CONSTRUCTION SUMMARY

Summer Ridge Estates Inc.

LOT NUMBER	PHASE	HOUSE TYPE	CLOSING DATE
017 BLOCK 291	1	ROSE GARDEN (25-02B2O) OPT 4 BEDROOM ELEV B2	12-Nov-25

BLOCK 291.TH. 17 25-02 ROSE GARDEN EL. B2 4 BDR. 1940 SQ. FT.

BASEMENT PLAN ELEV B2

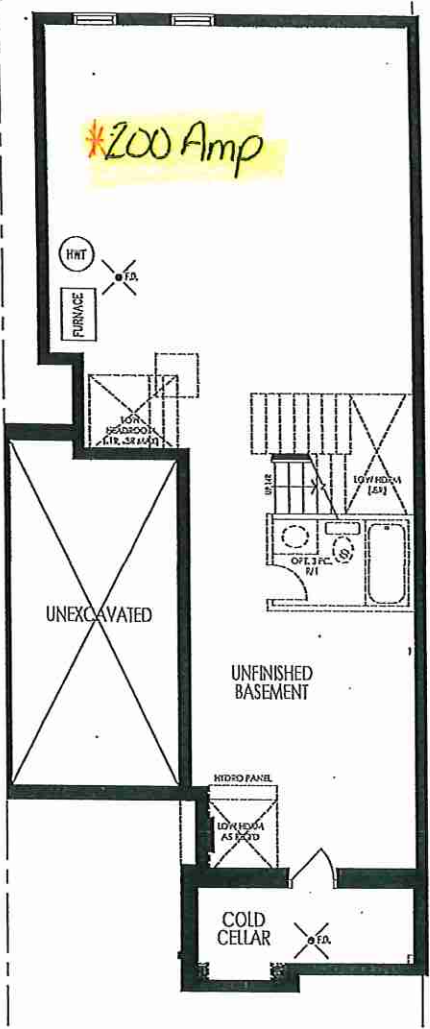
1 - BASEMENT - Install UPGRADE 200 AMP SERVICE in lieu of builders standard 100 Amp Service (See Sketch)

Cable - (x2)
Telephone - (x2)
Conduit (x1)

REVISED MAIN
GROUND FLOOR PLAN ELEV B2

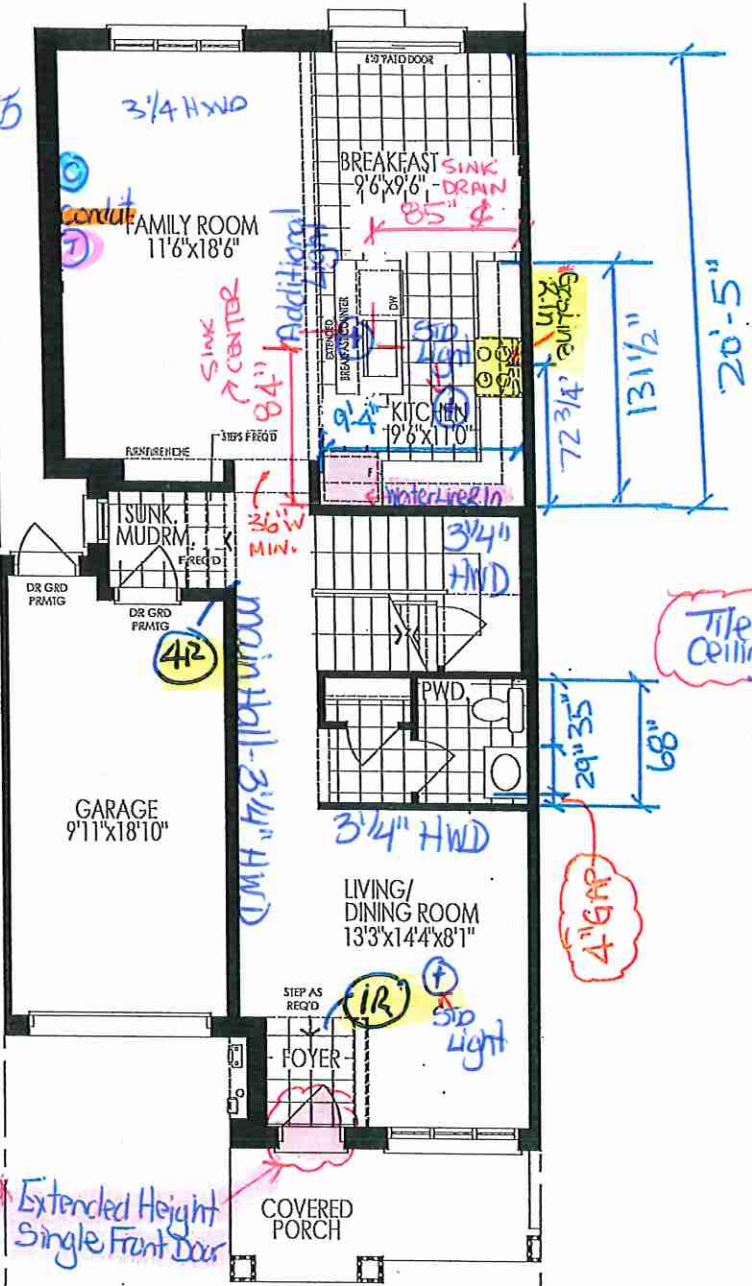
1 - Install Standard Cable Rough-Ins (x2) and Install Standard Telephone Rough-Ins (x2) (See Sketch) Note:
1 - KITCHEN - In addition to builders standard ceiling light, Install ONE (1) ADDITIONAL CEILING LIGHT Controlled by ONE (1) Seperate Switch at kitchen. To be installed centred above kitchen island (See Sketch) Note:
1 - LIVING ROOM / DINING ROOM - Re-locate builders standard ceiling light at dining room. To be installed centred at living room / dining room (See Sketch) Note:
1 - CLARIFICATION; EXTERIOR - GARAGE DOOR - Install STANDARD Exterior Handle with Lock on Garage Door Note:
1 - KITCHEN - CABINETRY - Increase Fridge Opening to 36" WIDE - To accommodate future installation of 36" wide fidge by purchaser After Closing (See Sketch) Note:
1 - APPLIANCES – INSTALL STANDARD APPLIANCE PACKAGE (See Attached) Note:
1 - KITCHEN - COUNTERTOP - Install UPGRADE #3 Stone Countertop – EVEREST TUSCANY with STANDARD " A " EDGE PROFILE - To be installed throughout kitchen, where applicable (does not include stone backsplash) (See Sketch) Note:

1 - EXTERIOR FRONT DOOR - Install UPGRADE EXTENDED HEIGHT SINGLE FRONT DOOR with Standard Glass (in existing Steel Clad Design) (delete transom window above) in lieu of builders standard height single front door (See Sketch)
Note:

1 - KITCHEN - Install UPGRADE GAS LINE ROUGH-IN TO STOVE *(Includes Additional Applicable Electrical)* at kitchen (See Sketch)

1 - KITCHEN - Install WATER LINE ROUGH-IN TO FRIDGE at Kitchen (See Sketch)

OPT. SECOND FLOOR
(W/OPT. 4 BEDROOM) PLAN, ELEV B2

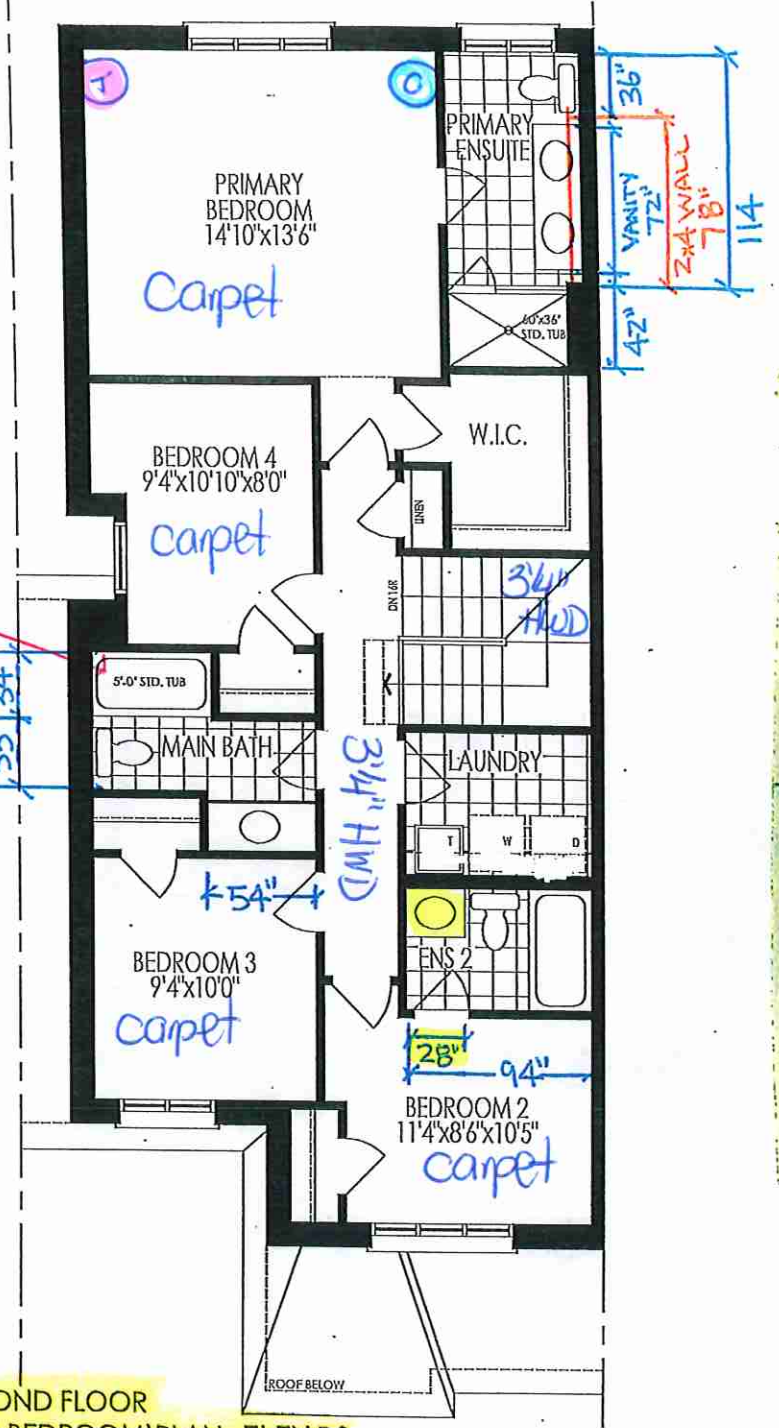
1 - MAIN BATH - TUB/SHOWER - Install STANDARD TILES (8x10 Serpentine White) at Main Bath Tub/Shower Ceiling, where applicable (See Sketch)
Note:

1 - CLARIFICATION - PLUMBING FIXTURES AND PLUMBING FAUCETS;
ALL BATHROOMS - Install Standard Plumbing Fixtures and Standard Plumbing Faucets throughout all bathrooms, where applicable. To Include; PowderRoom,PrimaryEnsuite,Ensuite #2 & MainBath (See Sketch)
